# The Sizewell C Project

## 9.10.12 Statement of Common Ground - East Suffolk Council and Suffolk County Council Appendix 11B: SZC Co.'s Second Set of LPA Request for Information Responses

SIZEWELL C PROJECT  
SZC CO.'S SECOND SET OF LPA RFI RESPONSES

**Figure 2.1: Receptor at Ford Gatehouse, Ford Road**

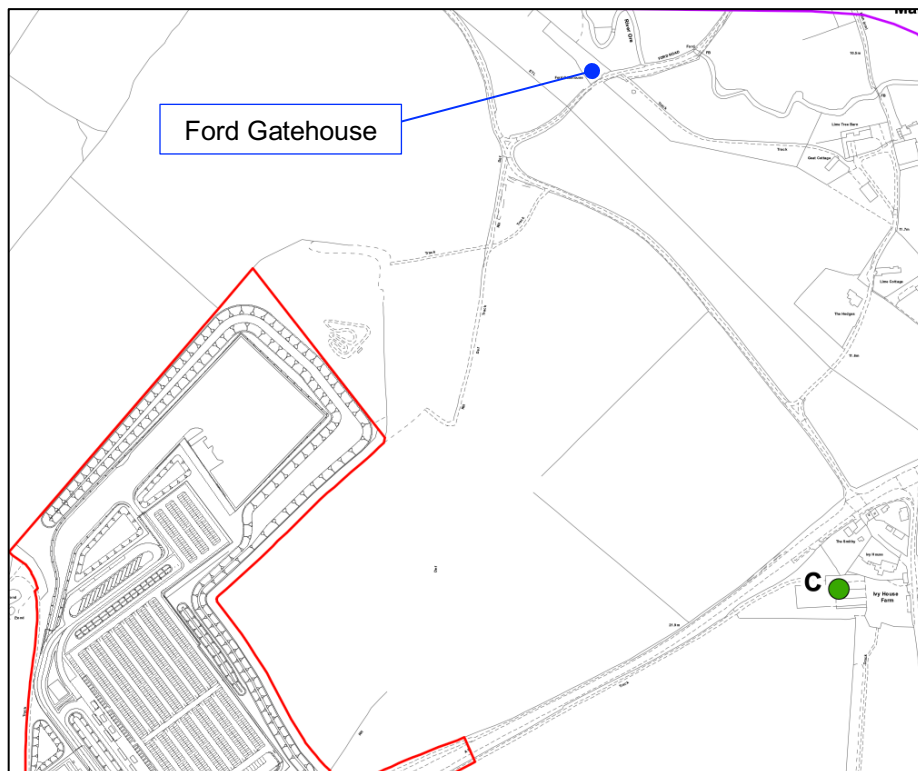
*The nearest residential property to the east would be Ford Gatehouse, Ford Road, as circled in red in Figure 5. This property is closer to the east site boundary than any properties in the vicinity of 'Receptor C' and ambient noise levels on Ford Road will be much lower than adjacent to the A12 (so will require additional baseline measurements per RFI 28). ESC therefore request that The Applicant provides an updated assessment which includes Ford Gatehouse on Ford Road to the east, circled in red.'*

- 2.2.14 The predicted levels at the closest receptor in Marlesford are expected to be similar to those at Receptor C, and consequently the effects would be either 'negligible' or 'minor', depending on ambient noise levels; in either case, the effects would not be significant in an EIA context.
- 2.2.15 To demonstrate this, additional calculations have been undertaken to determine the construction noise levels for each phase of works at Ford Gatehouse, Ford Road. The existing daytime ambient noise level at the receptor can be determined from **Volume 4, Figure 4.3** of the **ES [APP-386]**, which suggests a level of approximately 46 to 47dB.
- 2.2.16 The receptor location is shown in Figure 2.1.

2.2.17 The predicted construction noise levels and effects for Ford Gatehouse are shown in Table 2.1, for the same five phases of work set out in **Volume 4, Chapter 4** of the **ES** [APP-384]. The assessment of effects is based on a baseline ambient noise level of 46dB and takes account of the partial screening offered by the intervening topography between the receptor and the site.

**Figure 2.2: Receptors relative to freight management facility**

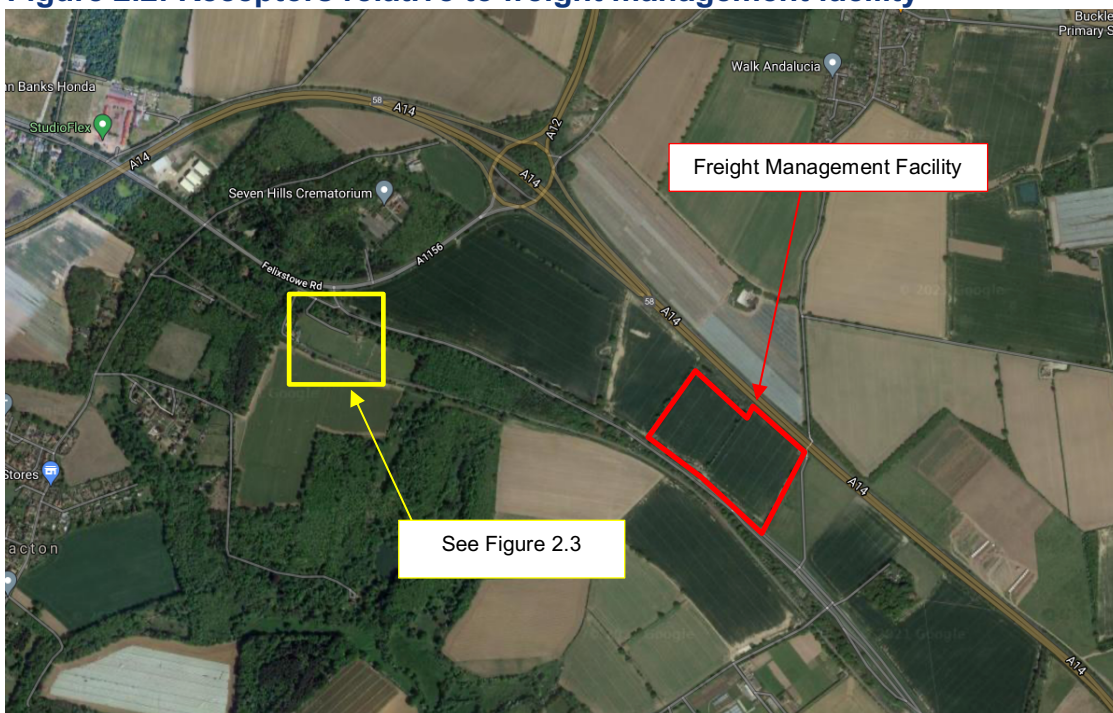
*As indicated in Figure 6, there are at least 2 residential properties on Felixstowe Road which could be subject to increased road traffic noise*

2.3.3 It is noted that there are three residential properties on Felixstowe Road, although two are set back from the road. These are shown in Figures 2.2 and 2.3.

**Figure 3 – Aerial photo showing distance from RT14 to main settlement of Marlesford**

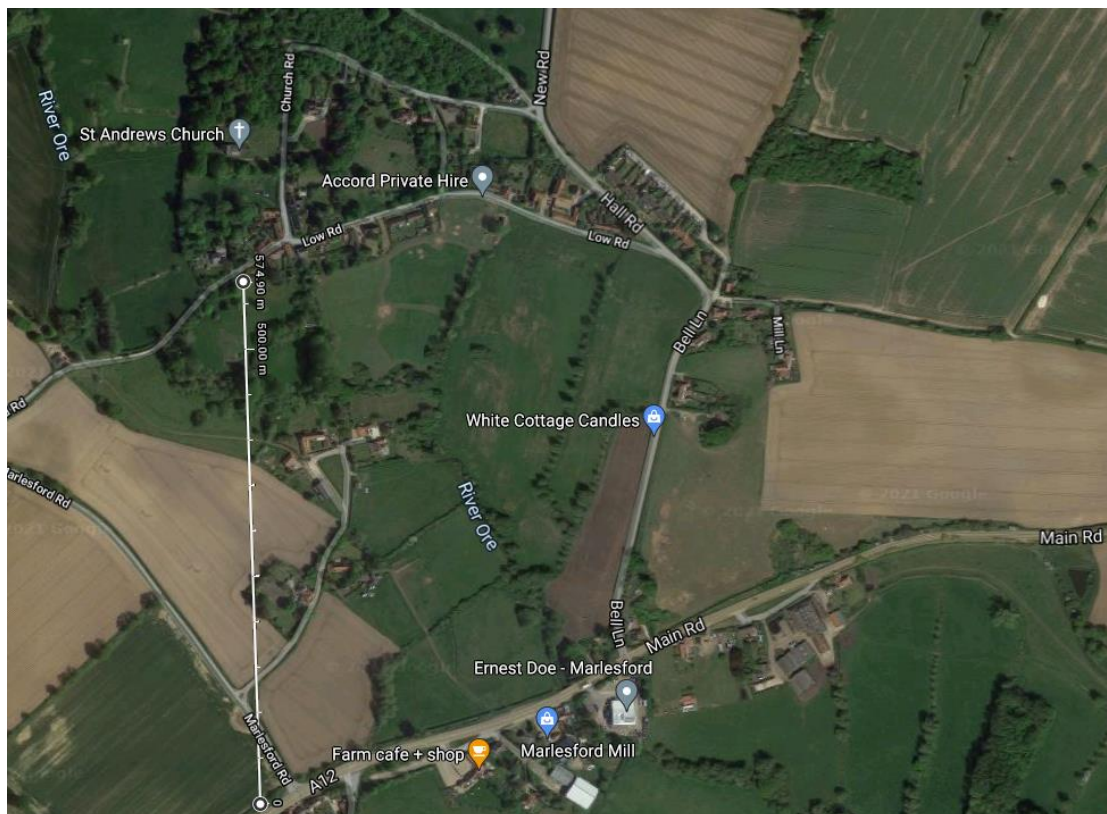
For these reasons we consider it unlikely that this monitoring position is representative of the nearest receptors in the main settlement of Marlesford.

It is very important that monitoring positions are representative of receptor positions because the construction noise assessment methodology requires an understanding of the prevailing ambient noise level. ESC request that The Applicant carries out additional measurements at more representative locations to validate the assessment, and/or provides otherwise satisfactory technical explanation of why additional measurements are not required. For Marlesford, a more representative location is likely to be much further from the A12, for the reasons outlined in RFI 29, below.

**Figure 4 – Figure 4.1 from Bk6, Vol4, Ch4 showing Receptor C and Marlesford (circled)**

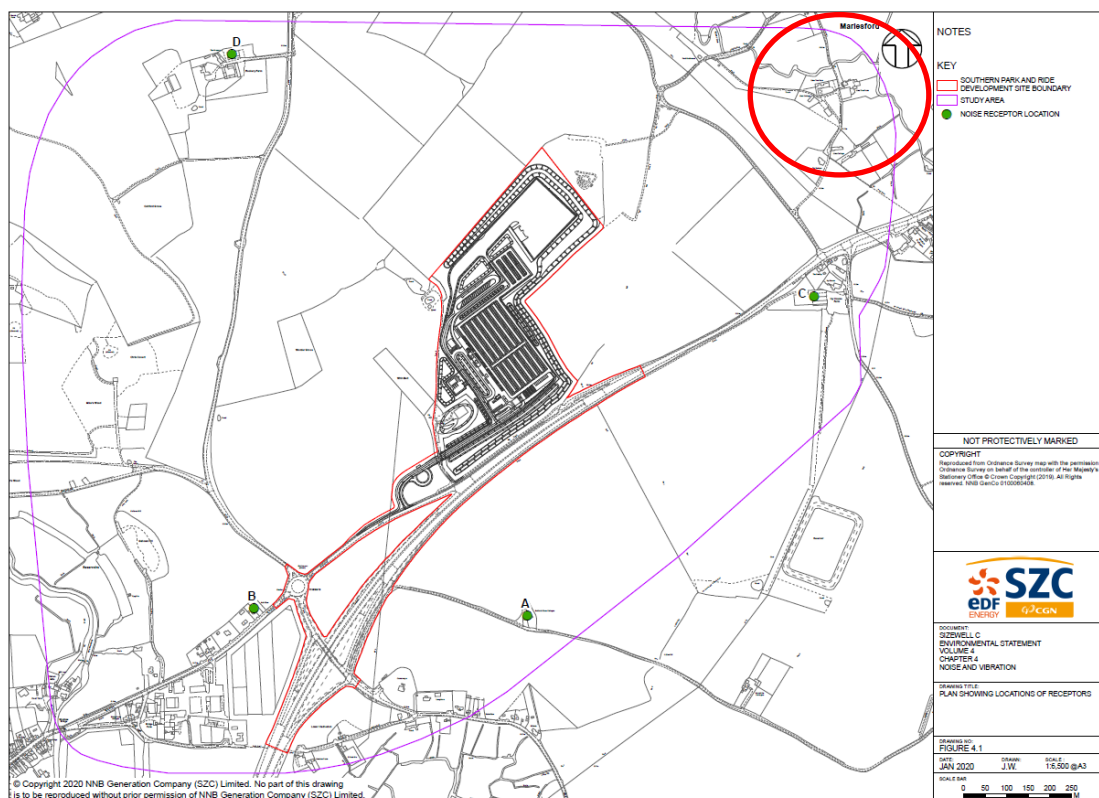
**Request for information 29** – This query is closely related to the second part of RFI 28. Receptor C at the Southern Park Ride Site is apparently intended to represent the village of Marlesford. However, as shown in Figure 3 this receptor location (and the associated baseline monitoring position RT14) is relatively close to the A12 and the main settlement of Marlesford is actually situated more than 500m away to the north.

Receptor C does not represent the nearest receptor in Marlesford.
